Clause 45 update

July 2001 Plenary meeting, Portland, OR

IEEE 802.3ae
Clause 45

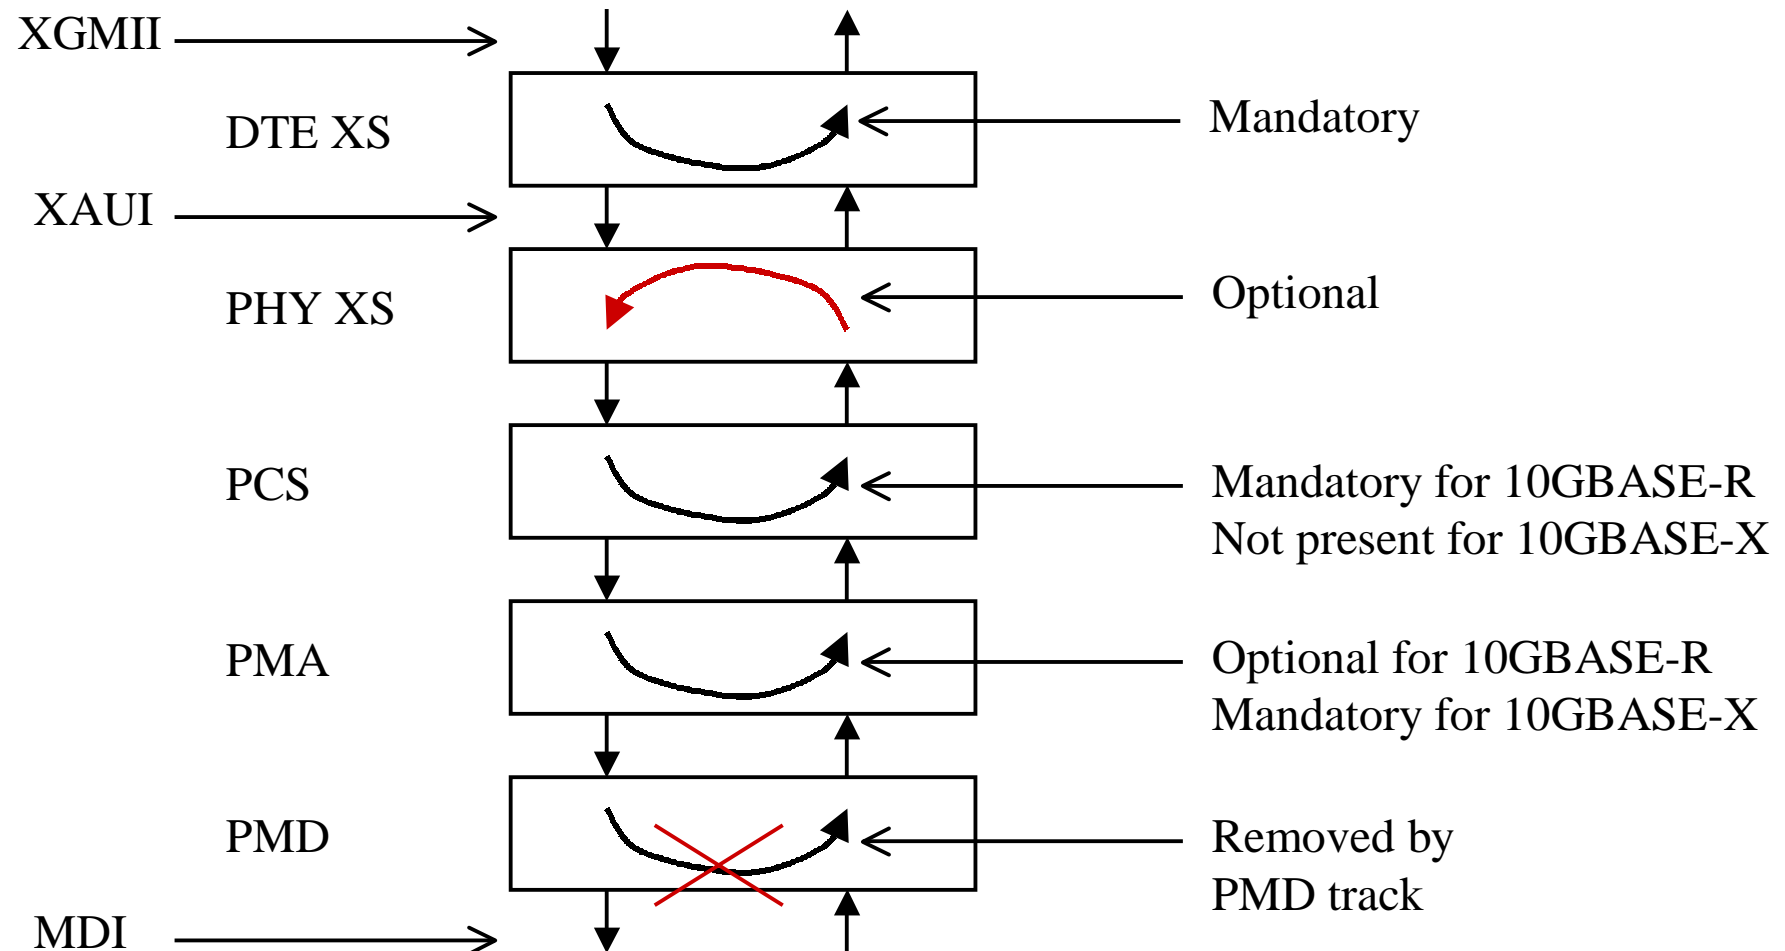
- 5 'TR', 7 'T', 11 'E'
- All but one 'T' resolved
- Loopback
 - Inconsistency between PHY XS loopback and all other MMD loopbacks.
 - Standard definition is that transmit is always from the MAC to the MDI and receive is always from the MDI to the MAC
 - But, PHY XS XAUI transmitter is in the receive direction
 - PHY XS loopback is now optional and is reversed compared to all other loopbacks.
 - i.e. it loops back from the receive path to the transmit path
